**SOIL & GROUNDWATER SITE ASSESSMENT:**

**DONGARY INVESTMENTS - OAKLAND**  
2225 7th street  
Oakland, CA. 94607

March 18, 1993      **RAMCON Job #476004**

GENERAL LOCATION MAP	
DONGARY INVESTMENTS- OAKLAND	
2225 7th Street	
Oakland, CA. 94607	
RAMCON Job #467004	Date: 03-18-93
Scale: 1" = 2,200 feet	Plate 1

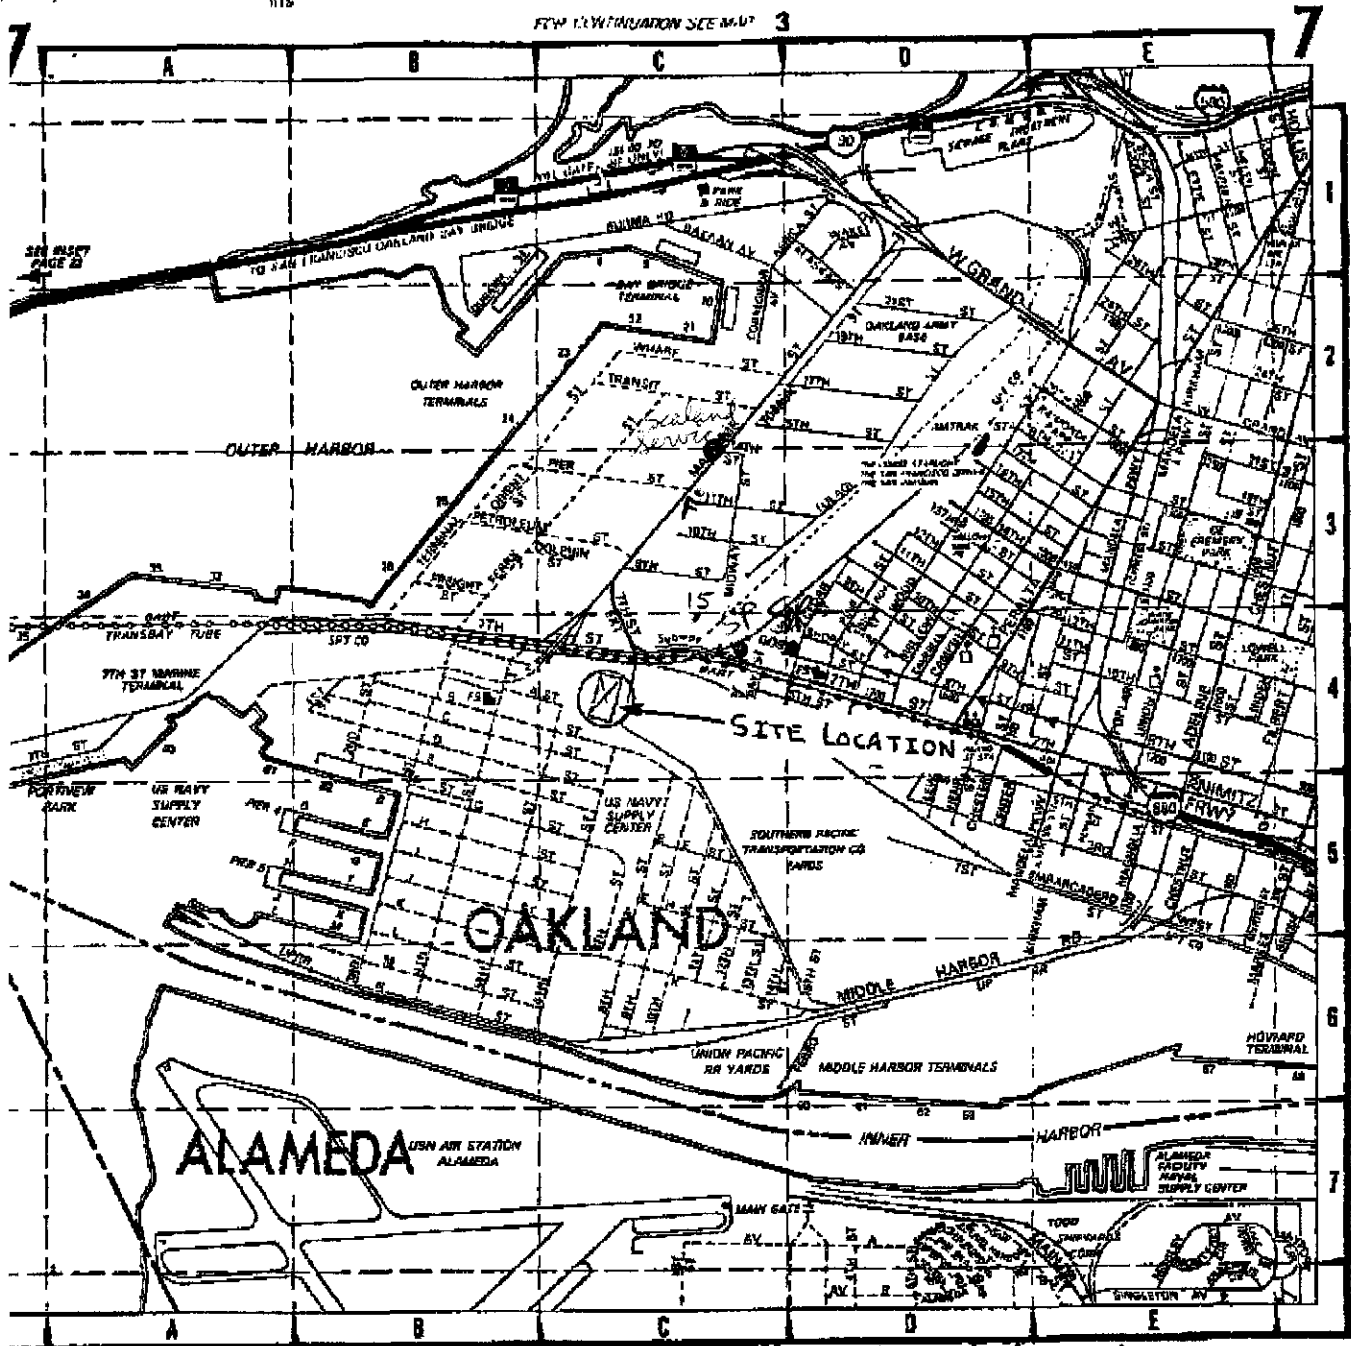
Oakland Army Base consistent  
 Site 15 WNW gradient  
 Site F NE to SE  
 (June 92 QR by SCS)

NSC - Brian doesn't know  
 if there's a map w/mw locations.  
 The tank pulls he did  
 were ~ 1 mi from 7th St.  
 (near Bay)
